**NSLPP MEETING HELD ON 04/12/2024****Attachments:**

**ADDRESS:** 1 Warung Street, McMahons Point**APPLICATION NO:** DA 85/2024**PROPOSAL:** Demolition of existing structures and erection of a new residential flat building and ancillary works**PLANS REF:**

**OWNER:** Highbury Warung Pty Ltd**APPLICANT:** Highbury Warung Pty Ltd**AUTHOR:** Report of Thomas Holman, Senior Assessment Officer**DATE OF REPORT:** 24 October 2024**DATE LODGED:** 17 April 2024**DATE AMENDED:** 19 September 2024**RECOMMENDATION:** Refusal

**DRAWING NO.** DA-301  
**ISSUE** C

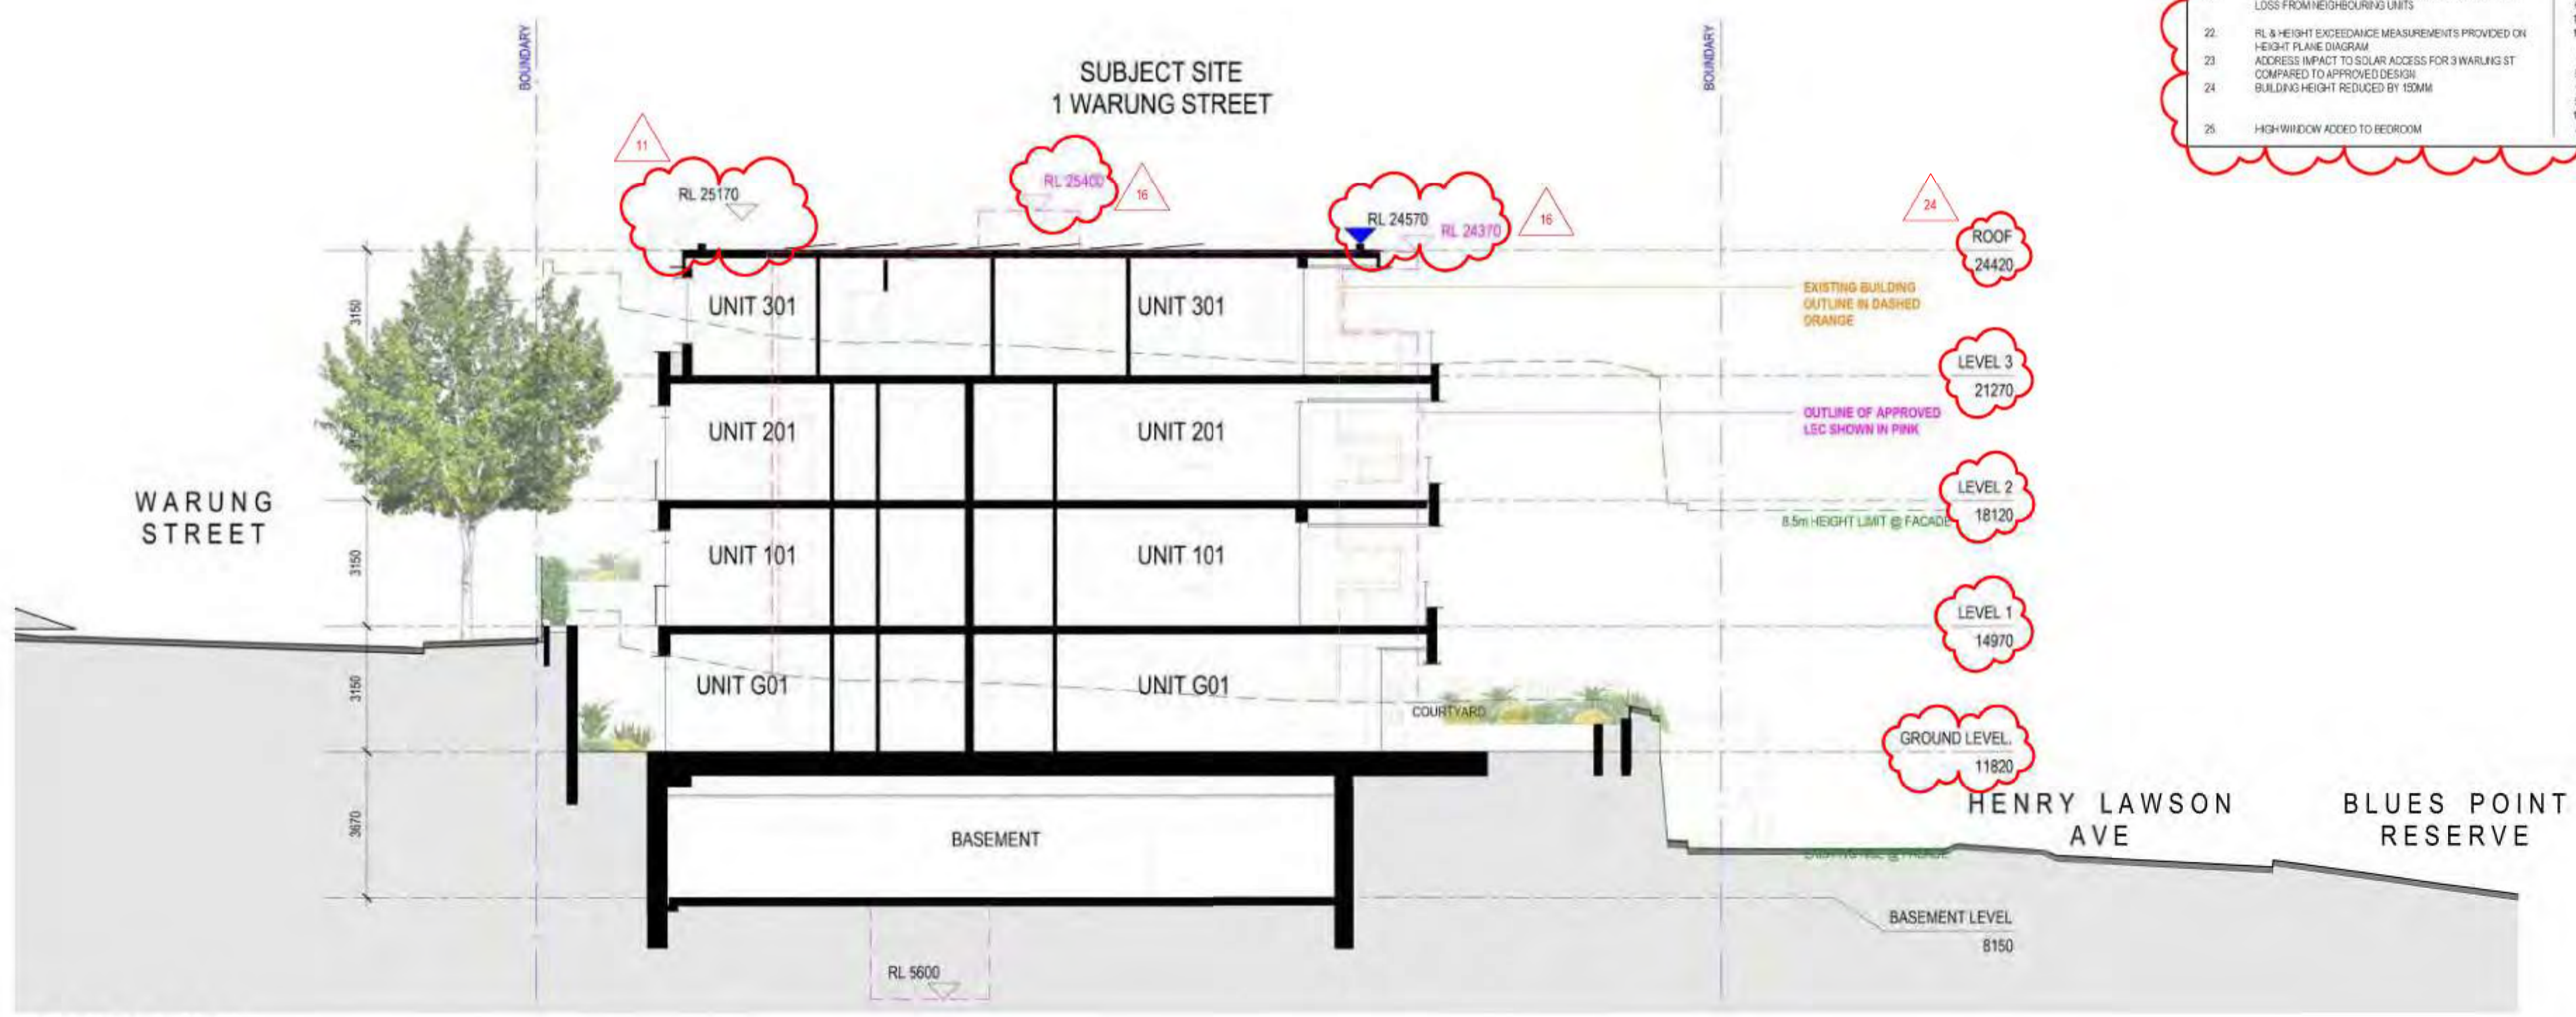
Figure 23 – Sections Sheet 1, DA-301 Issue C

1 **BUILDING ENVELOPE - EXISTING**  
@ A1

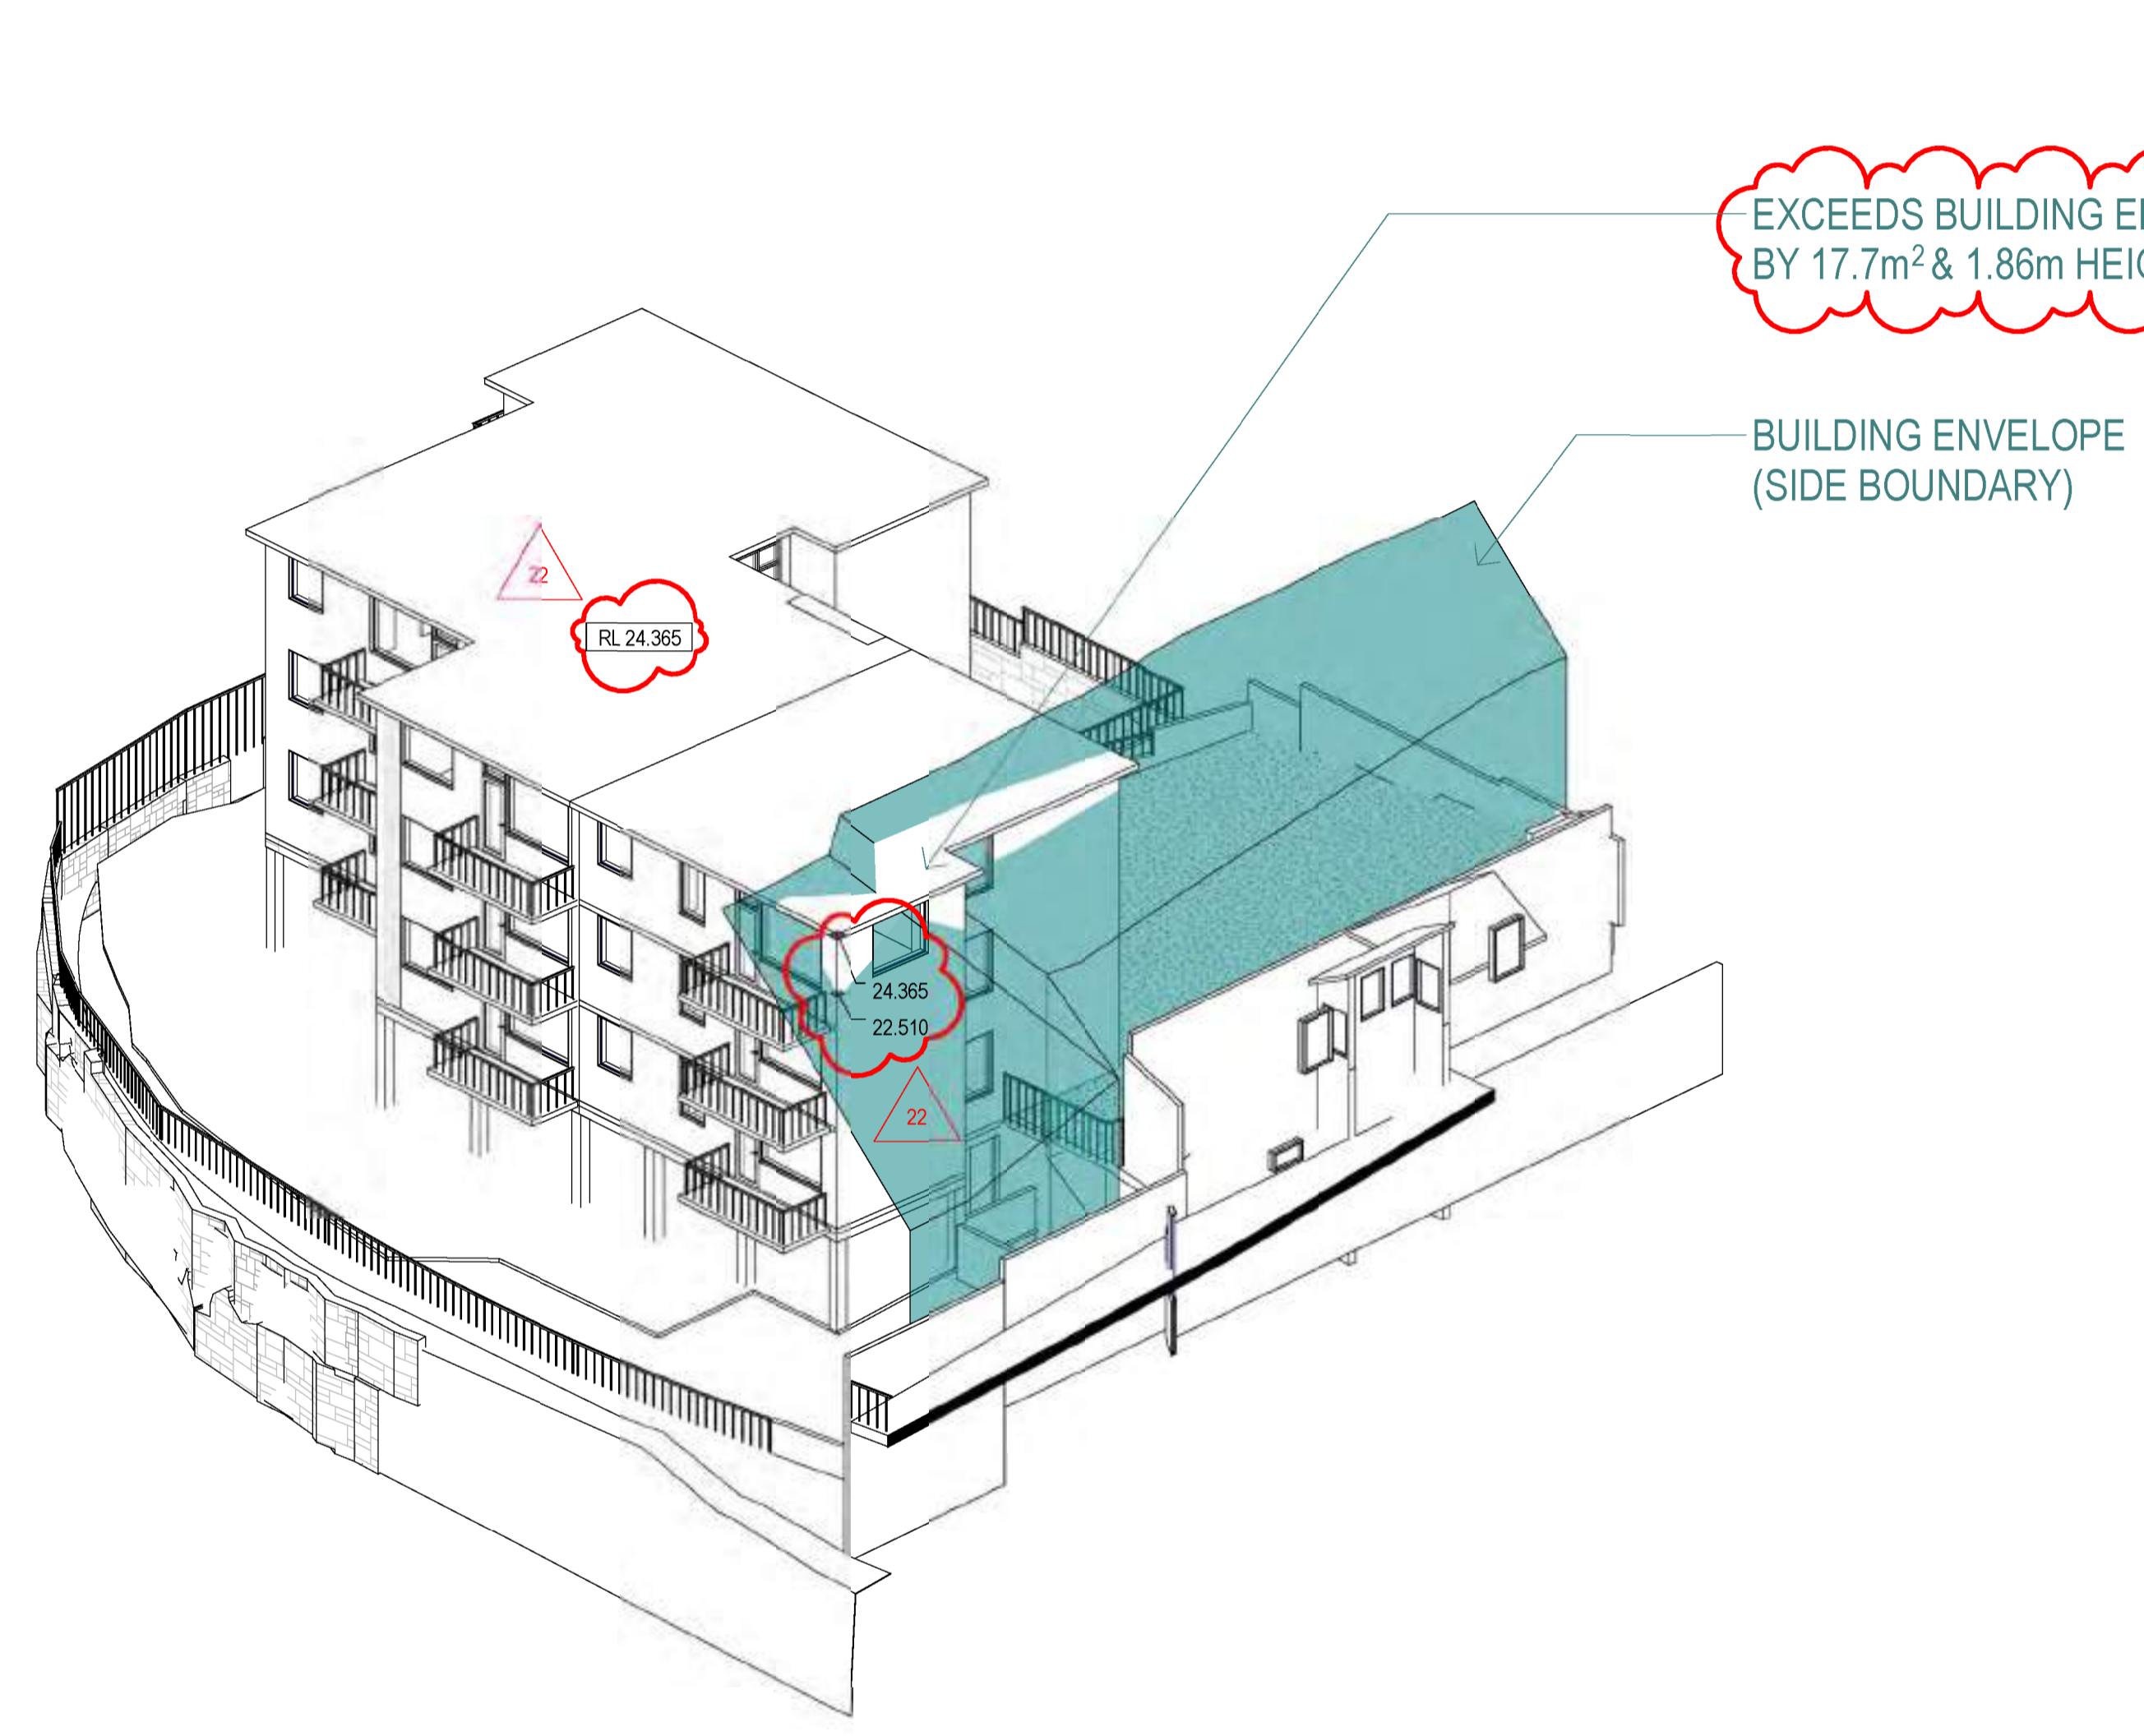
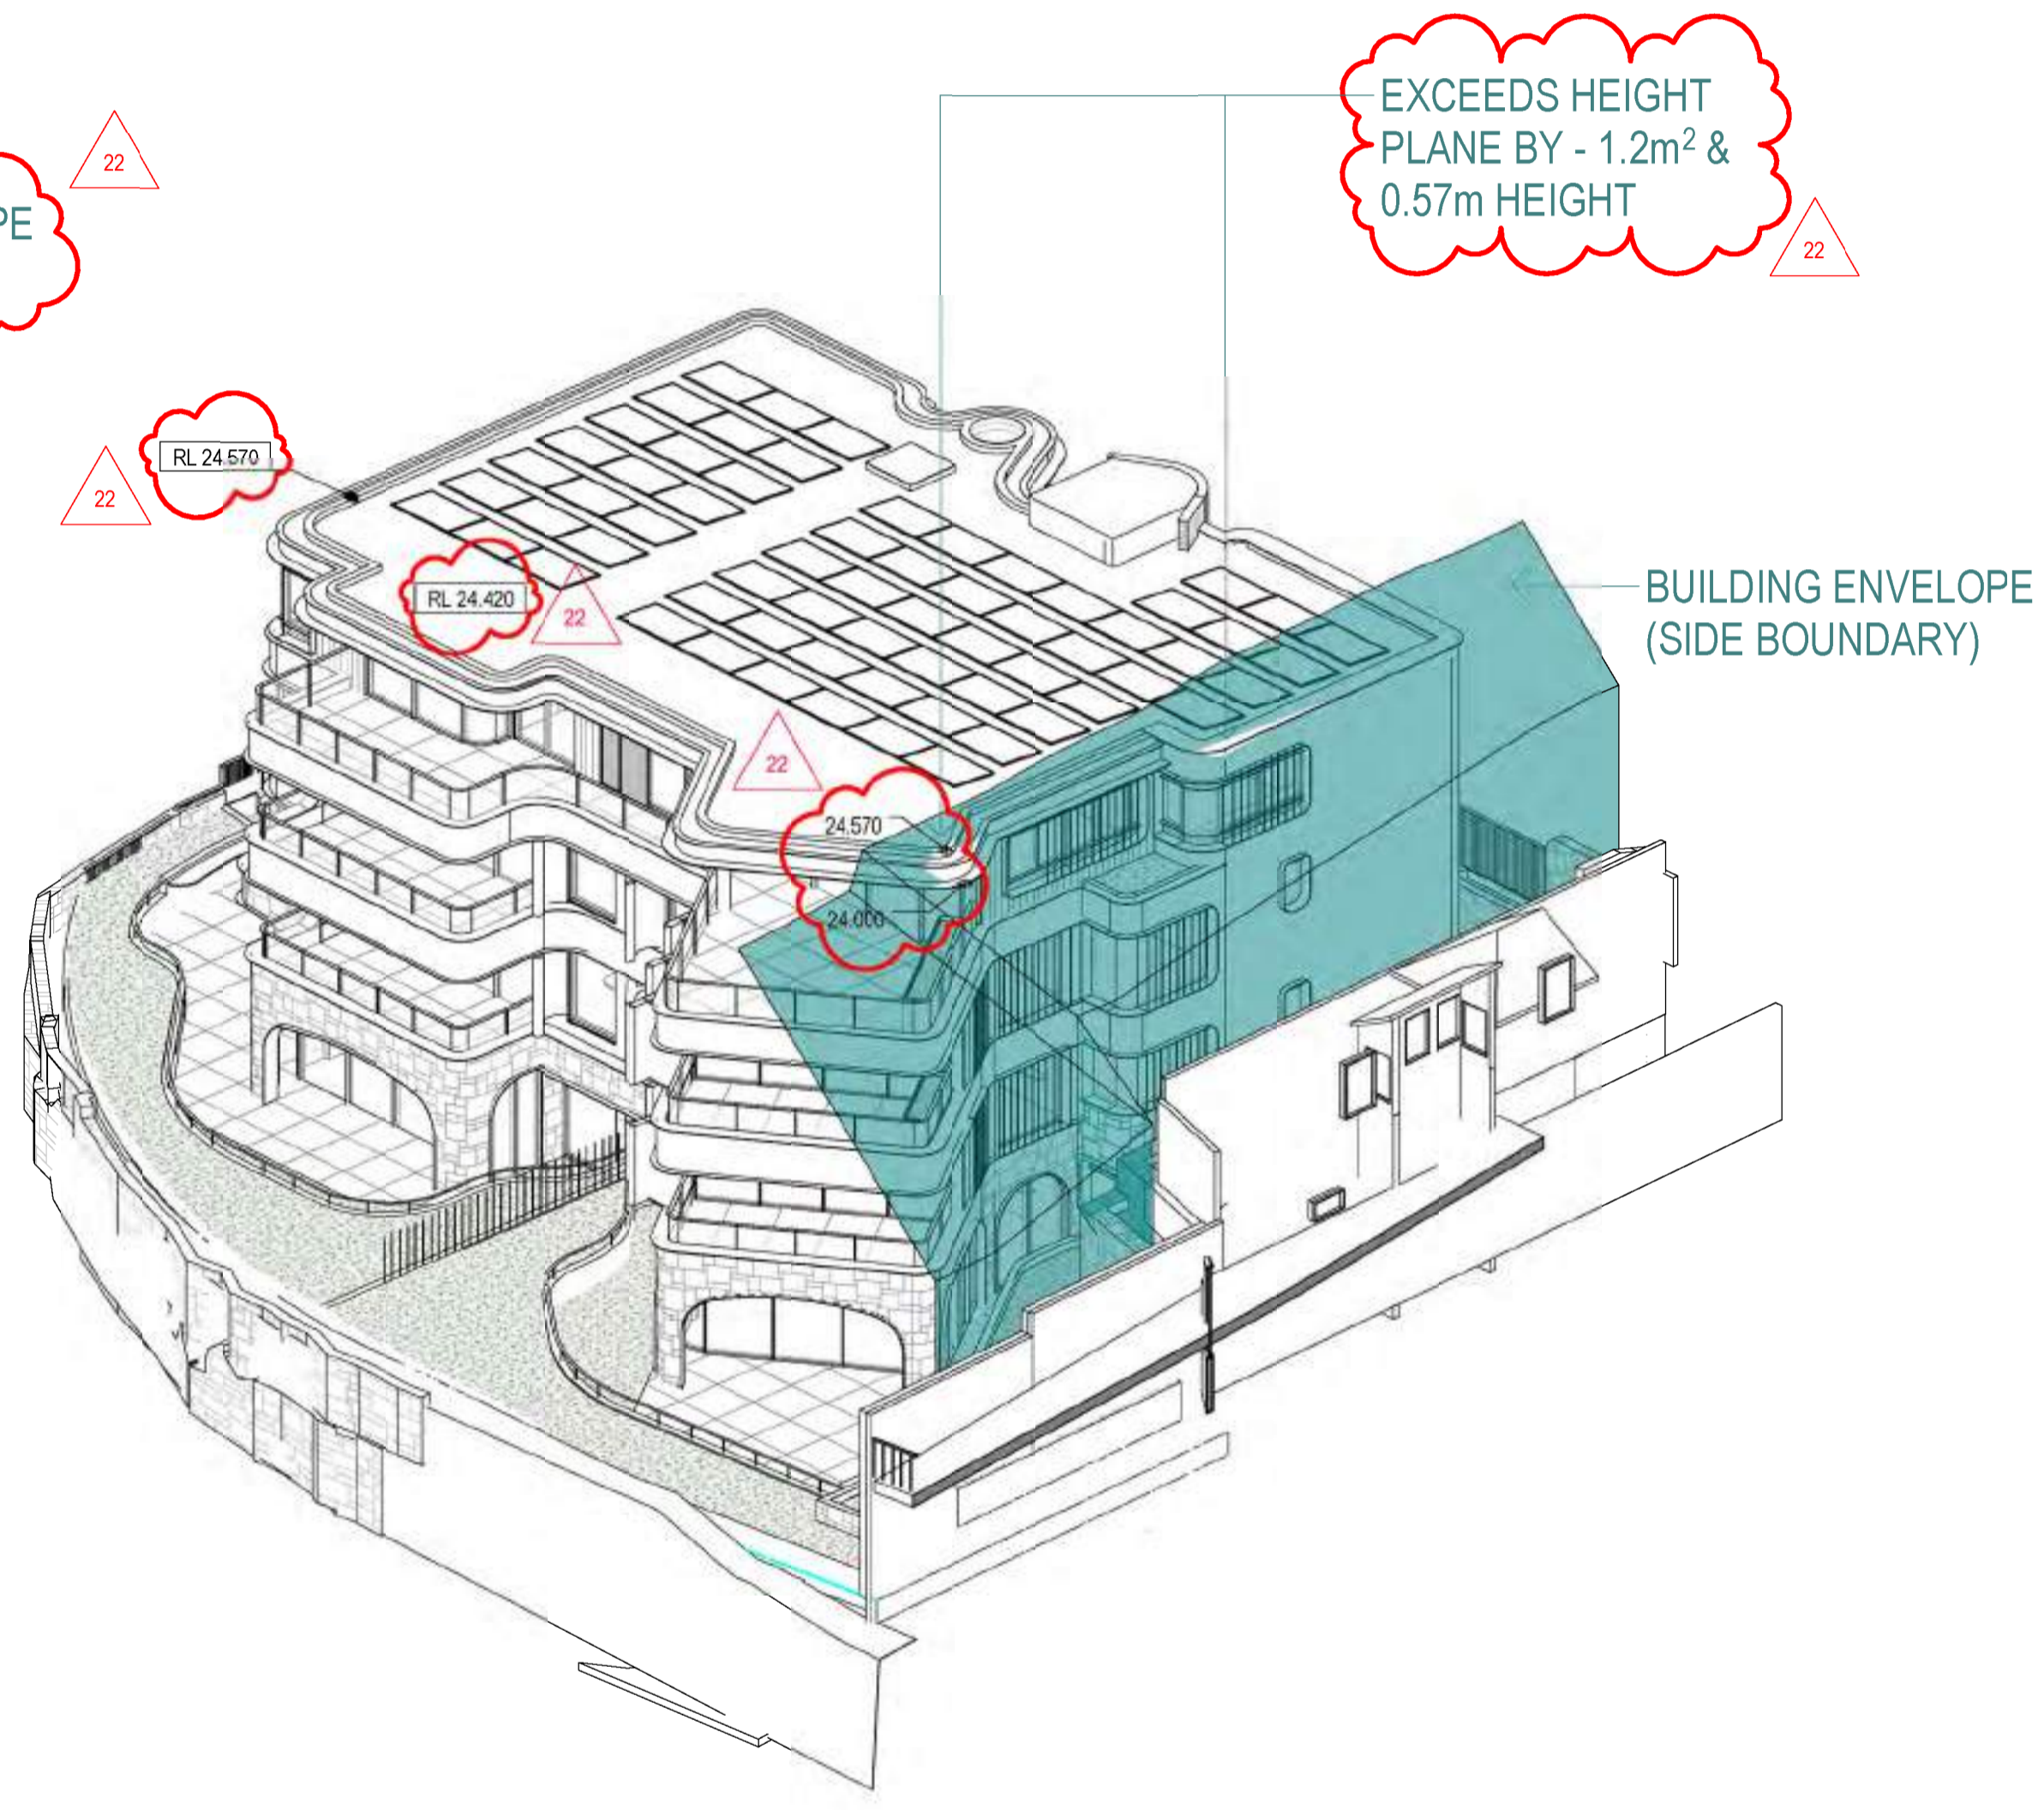
**Figures 21 & 22 – Building Height Plane - Existing (left) and Building Height Plane – Proposal (right), DA-552 Issue C**
